Owner Change Order (OCO)

Project Name: Brookline - Driscoll School
Gilbane Project No.: J08864.000

OCO: OCO-0015

Scope Of Changes: OCO 15 Misc. Changes

Add one beam as shown on Floor 3 Framing.
Detail S103A

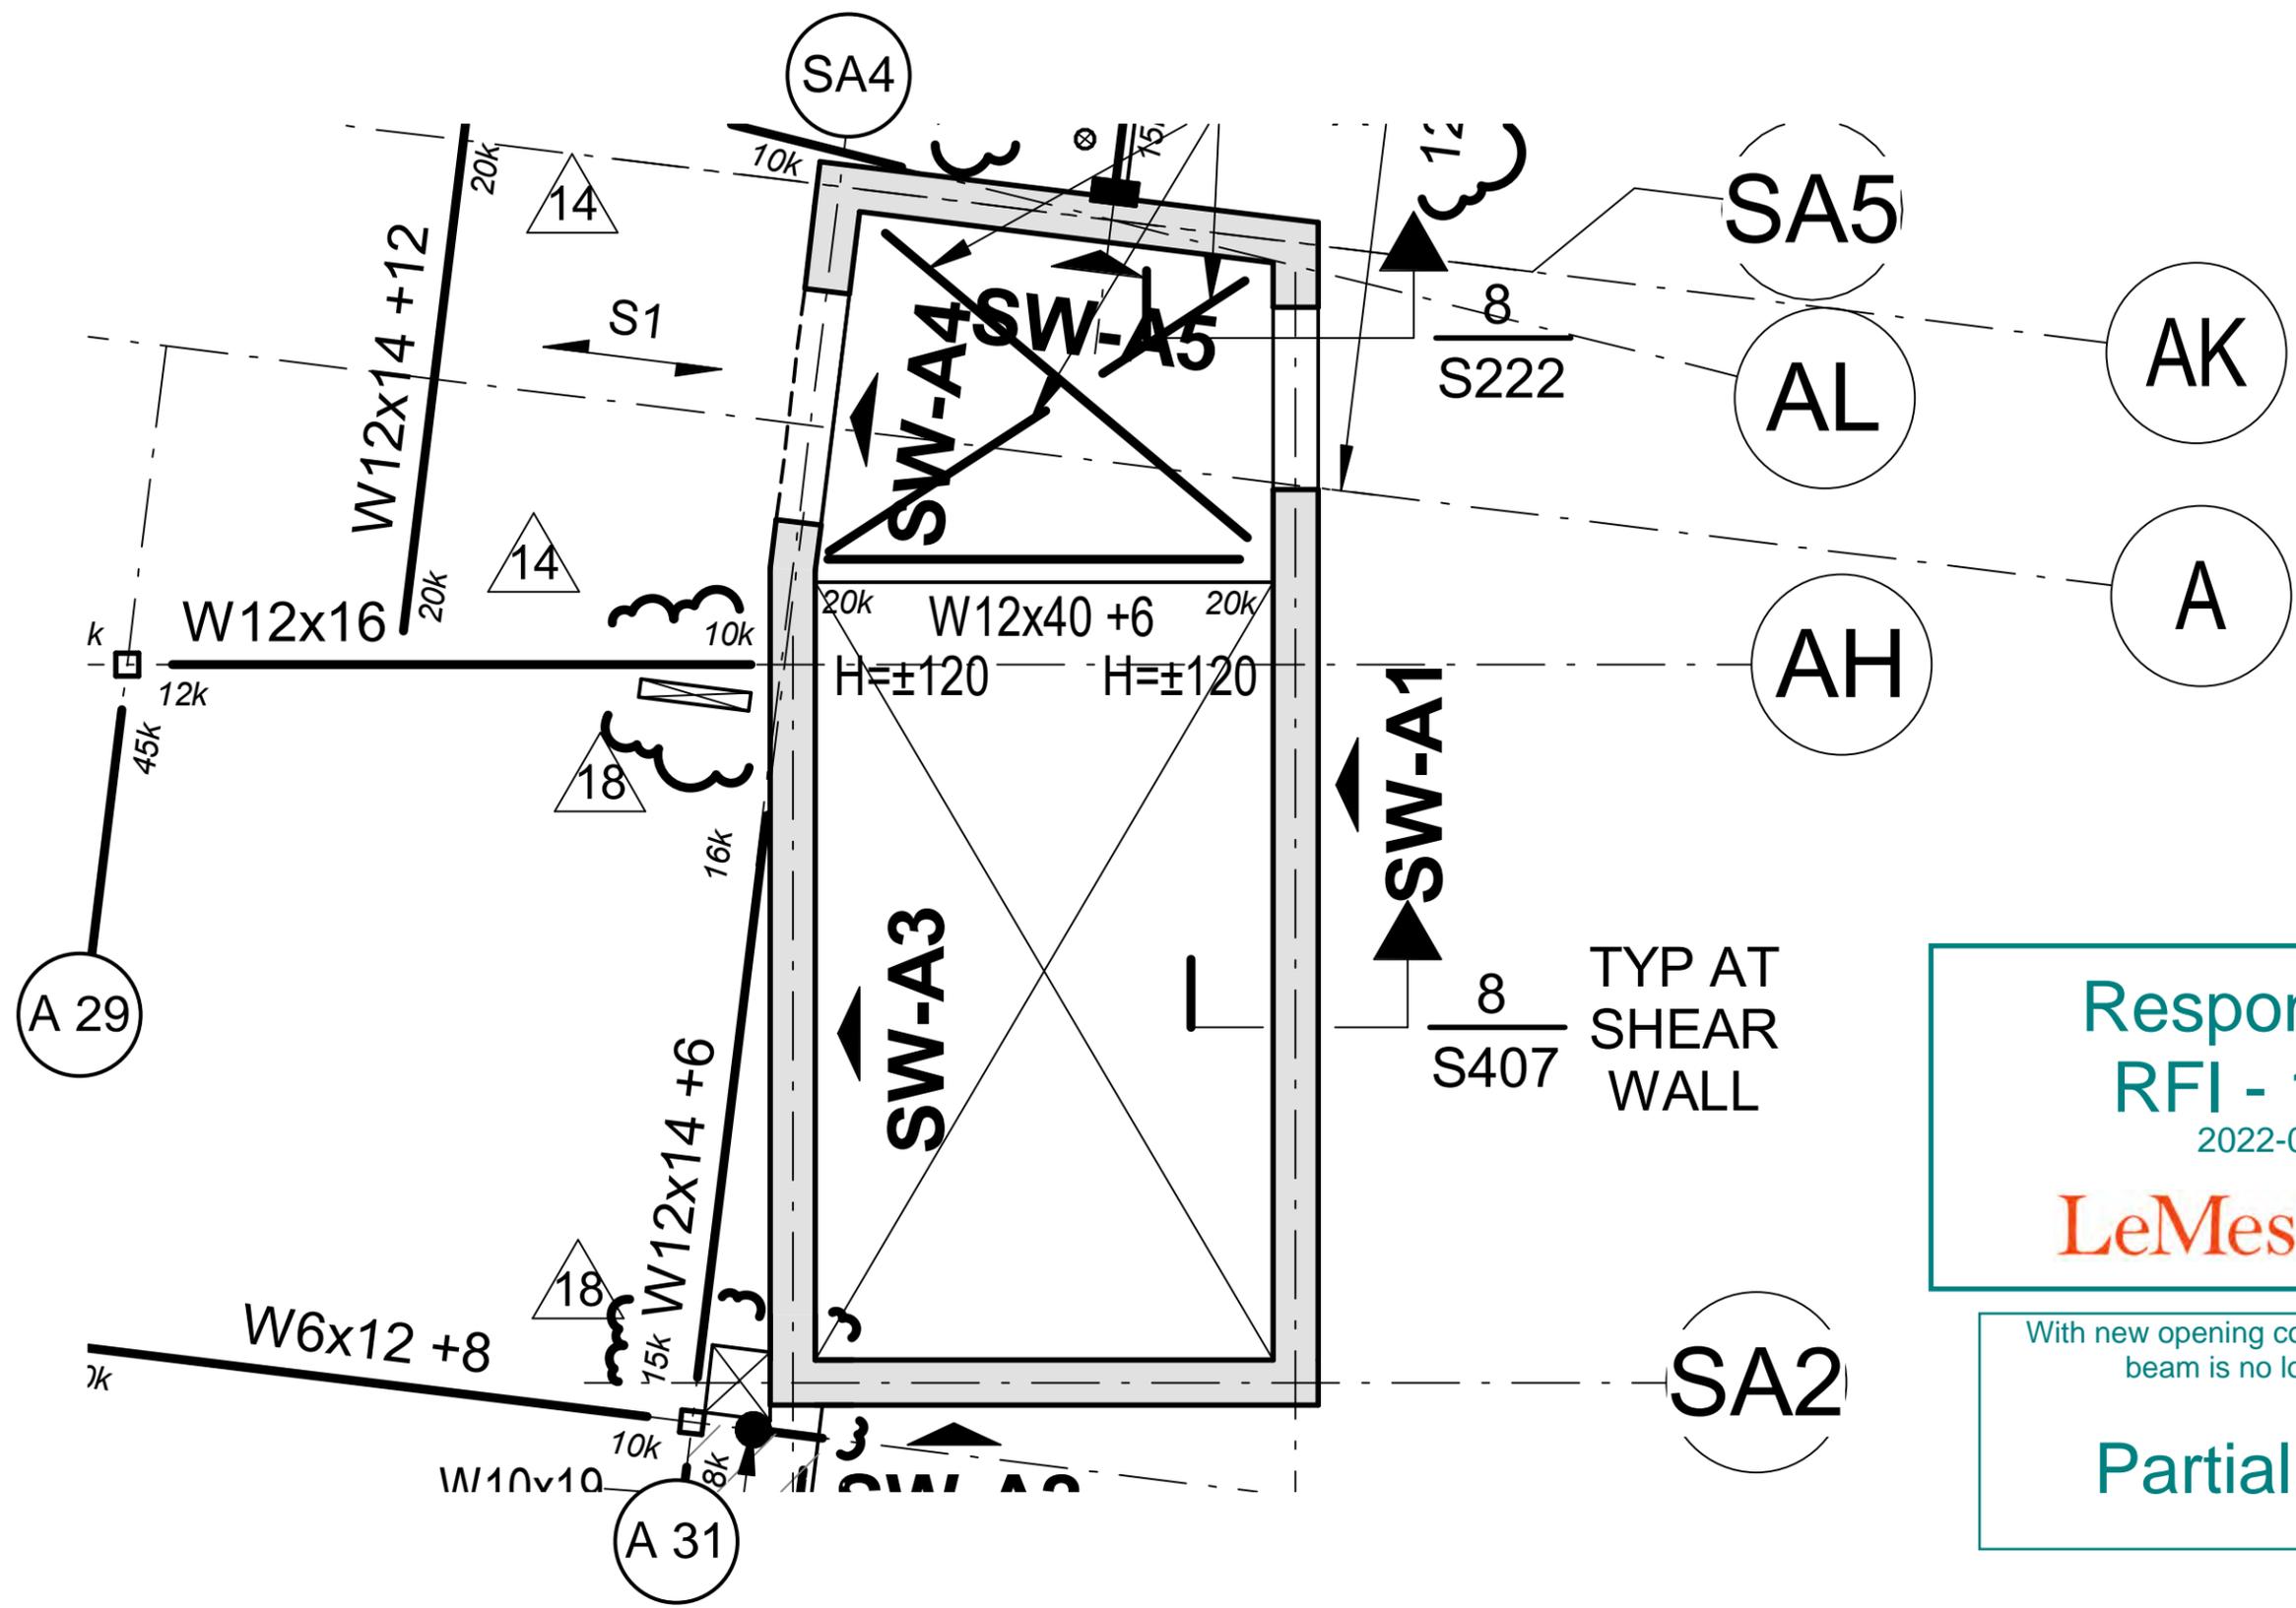
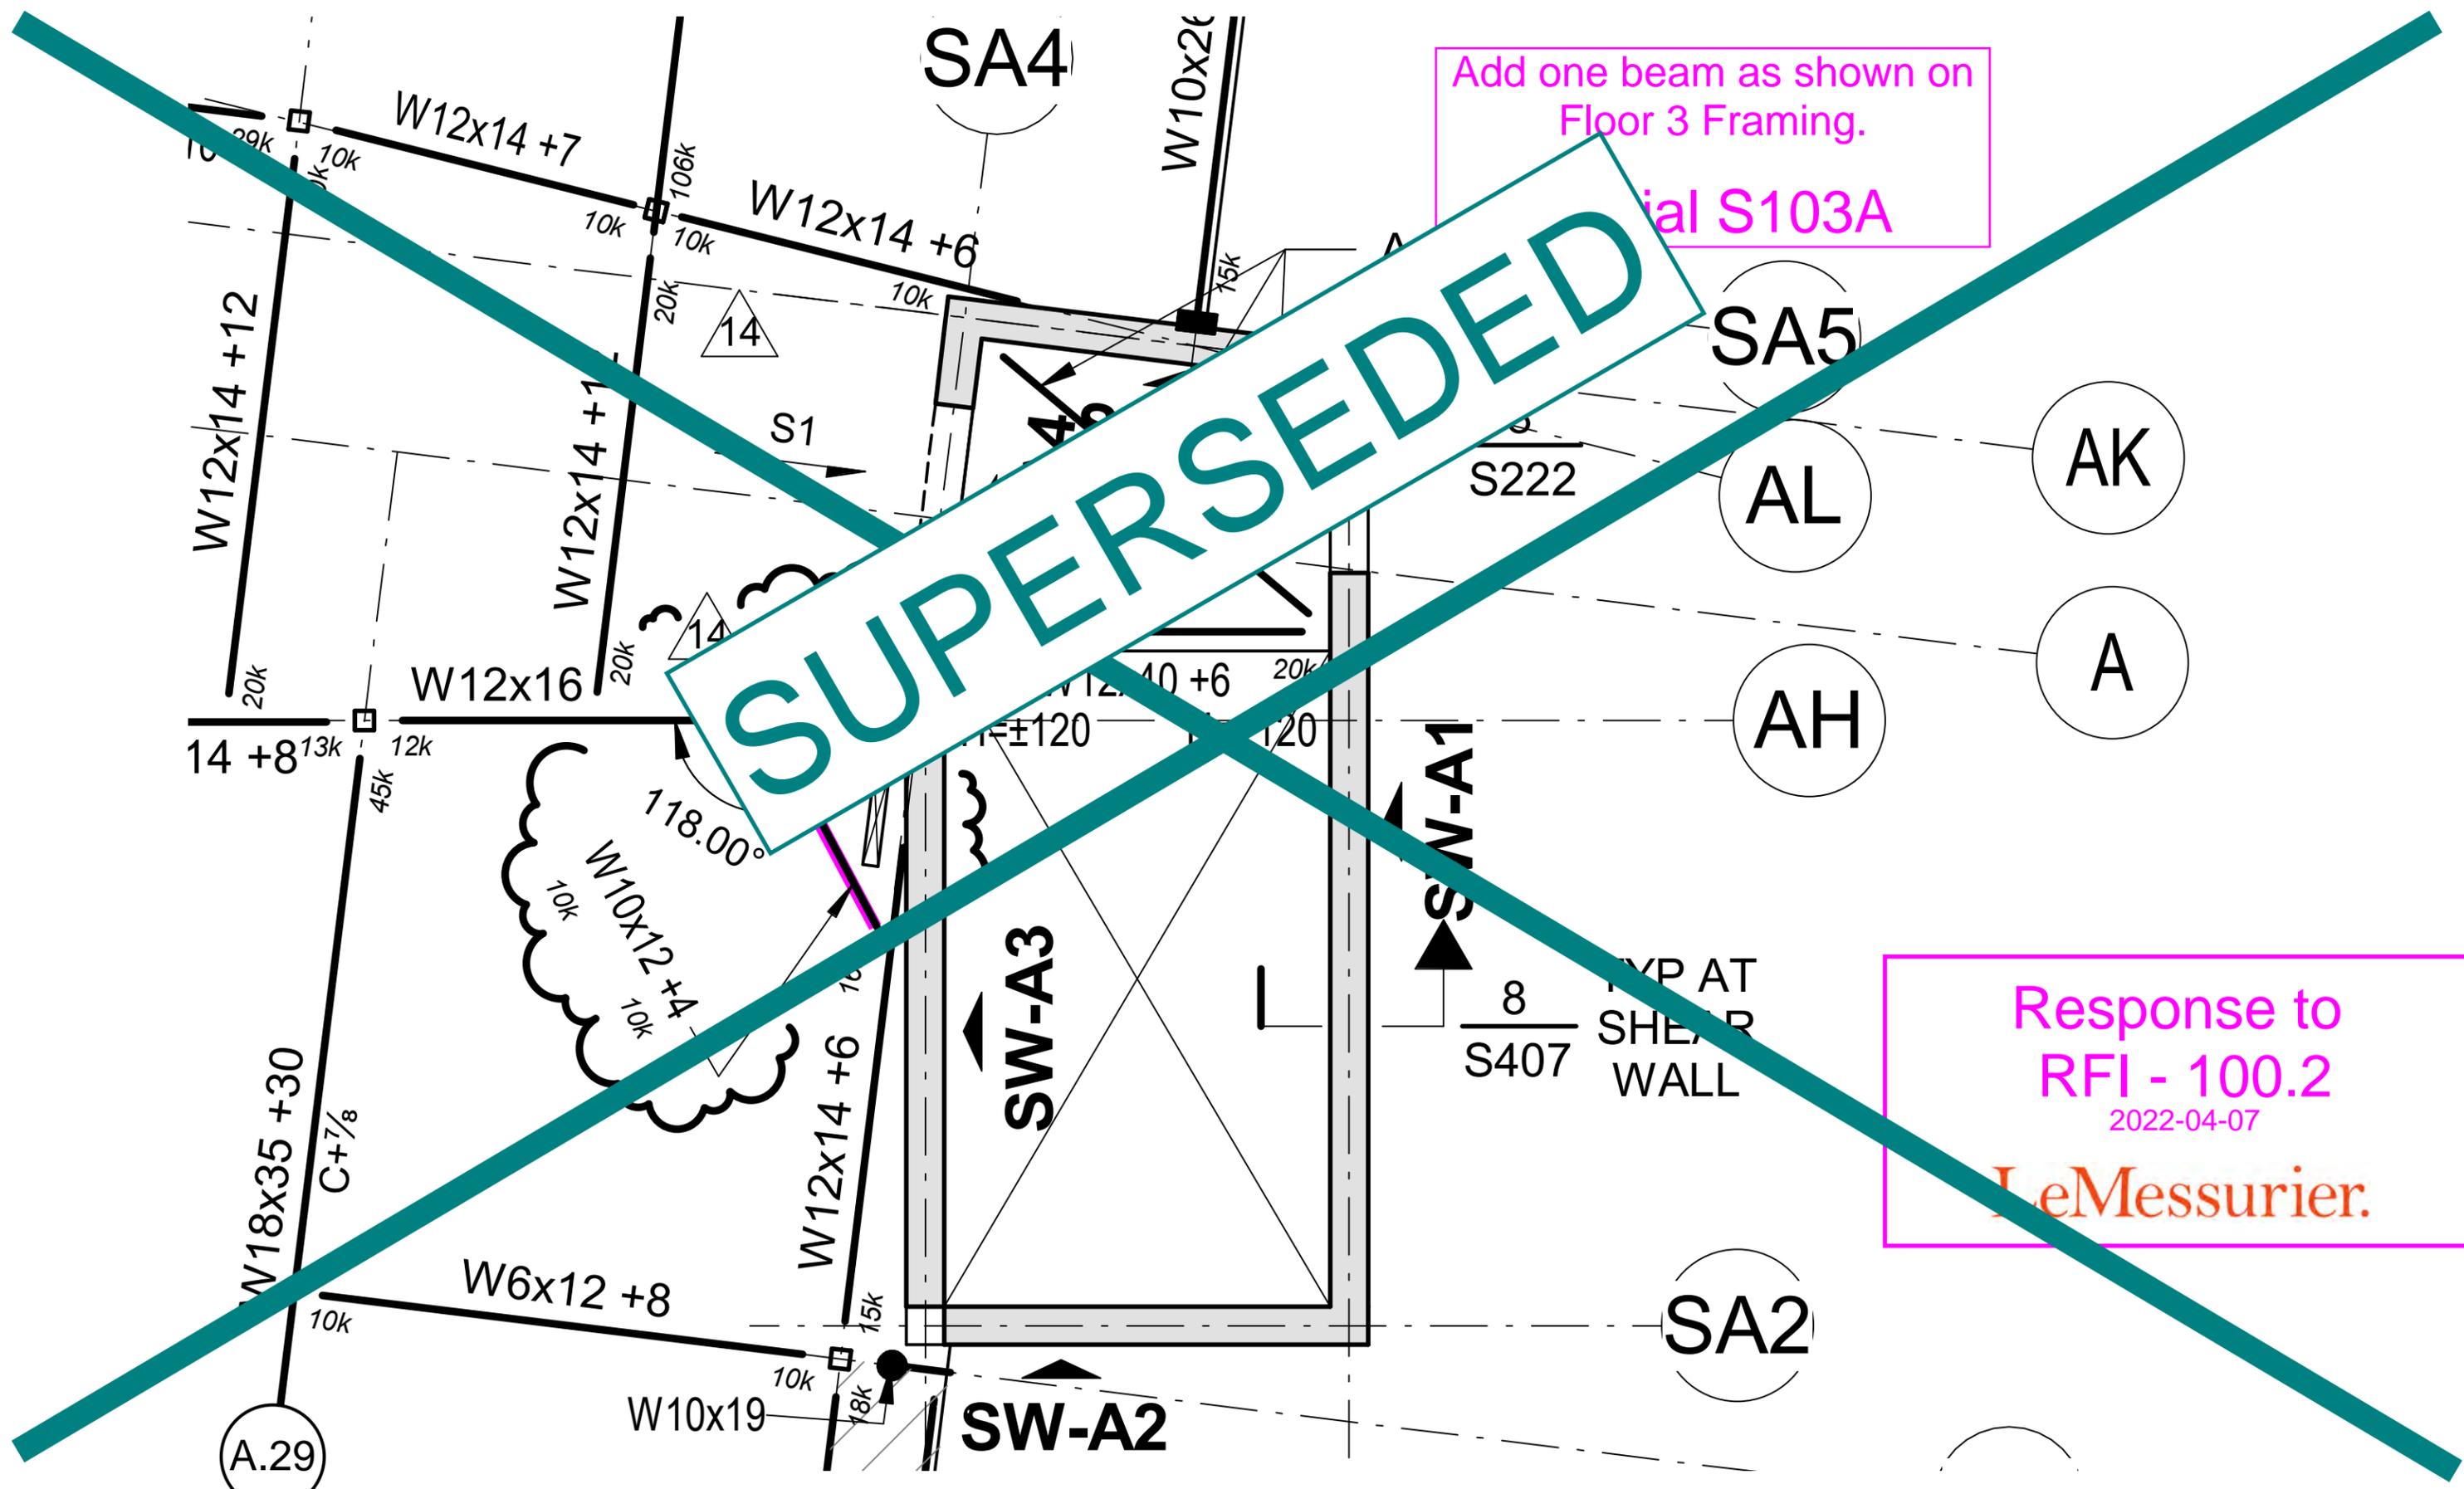
See attached for UPDATED LeMessurier response in teal.
JLA to provide dimensions for new opening configuration.

FW- 220B033

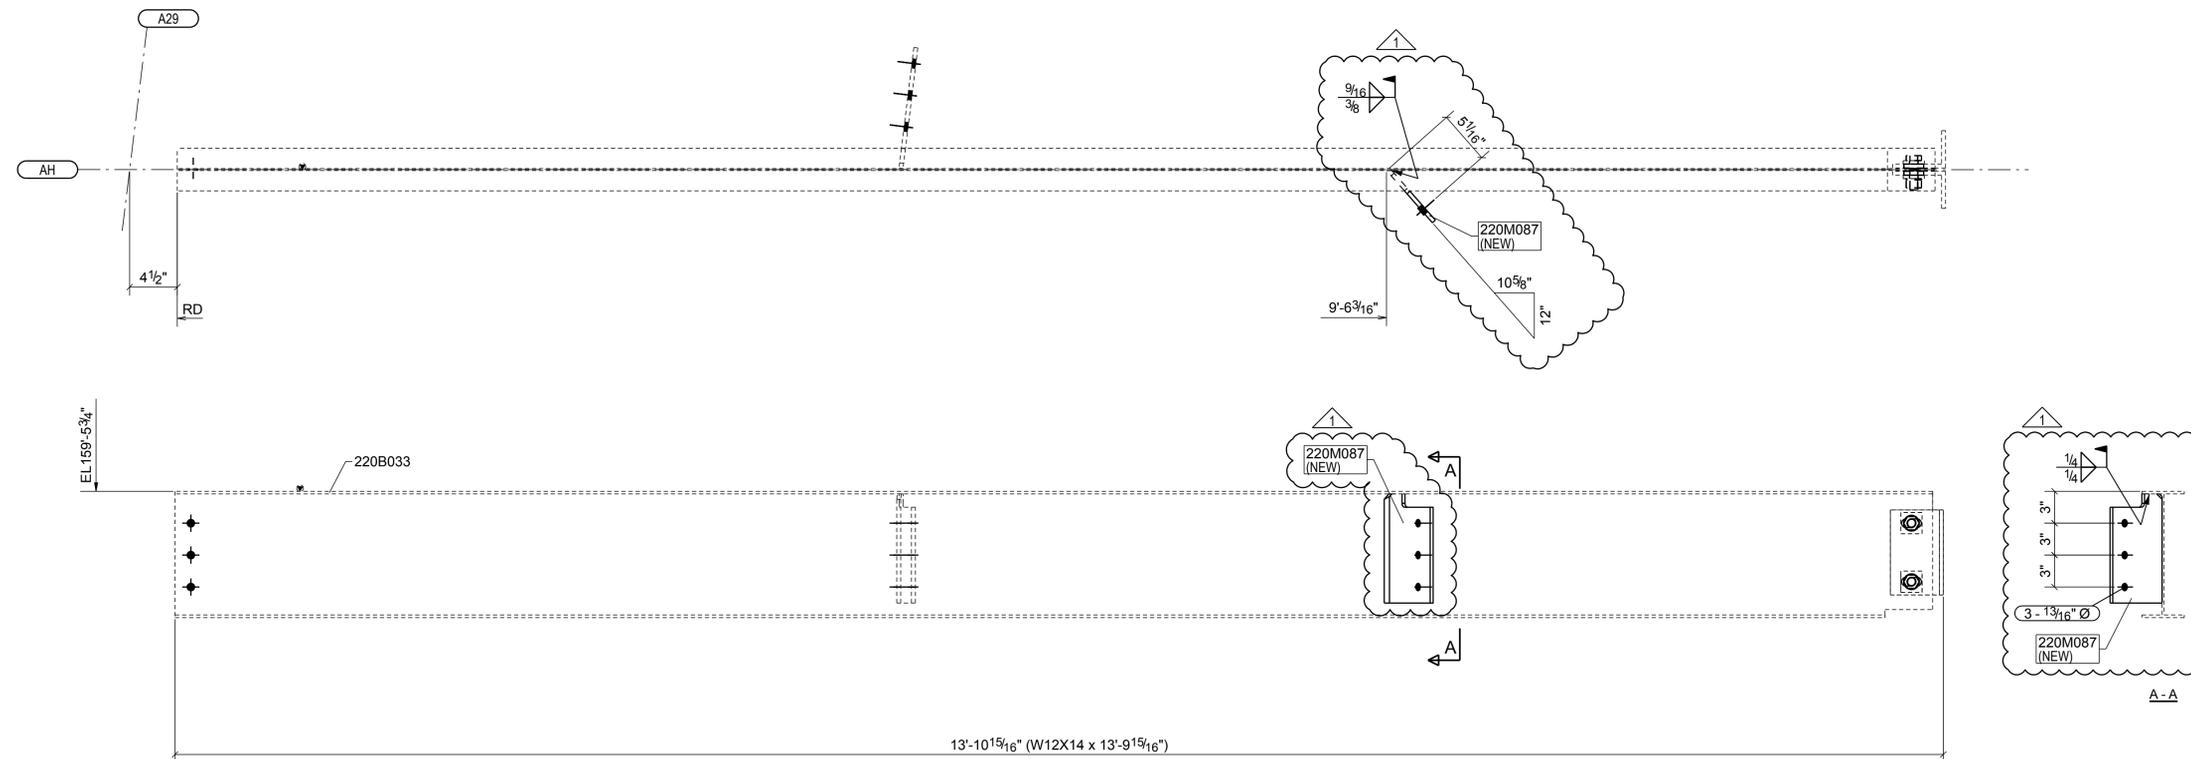
FIELD WORKS:
 LOCATE AS SHOWN AND FIELD WELD NEW
 220M087 SHEAR PLATE CONNECTION
